# intel® Technical Advisory

TA-0796-00

## Intel® Server Chassis SR1400/SR1450/SR2400 – CDROM Tray and Floppy Tray may be incorrect

Figure 1: CDROM Tray with misoriented pins

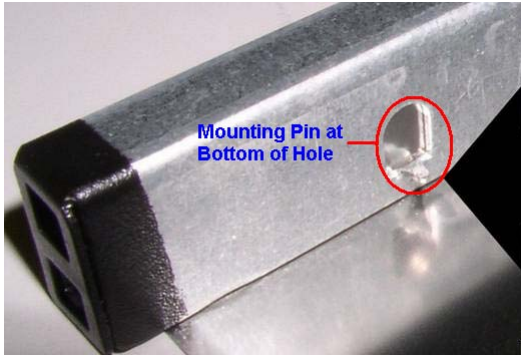
An issue has been identified with both the CDROM tray and the Floppy tray used in Intel Server Chassis SR1400/SR1450/SR2400. The mounting pins of both the CDROM tray and the Floppy tray may be misoriented. As a result, the CDROM or the Floppy can not be installed into the tray with misoriented mounting pins.

See below figure 1 for the CDROM tray with misoriented mounting pins and figure 2 for the CDROM tray with correctly oriented mounting pins.

During the tray assembly, the mounting pins may be oriented incorrectly.

The manufacturing process has been corrected to prevent misorientation of the mounting pins.

Customers who encounter this issue can request a replacement tray. For a replacement tray, contact Intel using your standard warranty process. Please indicate that you are calling regarding TA# 0796-00, and have the following information when you call; the part number requested: 6070A0074602 for the CDROM tray, 6070A0074702 for the Floppy tray, and the serial number(s) for the system(s) needing the replacement part.

Figure 3: Floppy Tray with misoriented pins

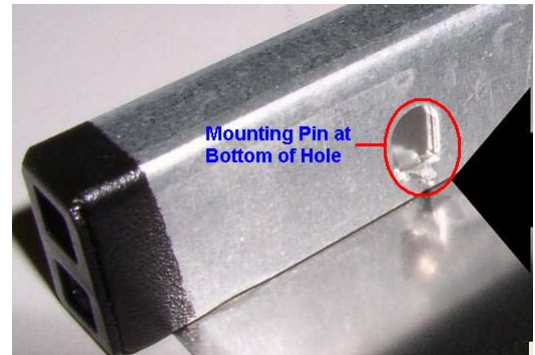
See below figure 3 for the Floppy tray with misoriented mounting pins and figure 4 for the Floppy tray with correctly oriented mounting pins.
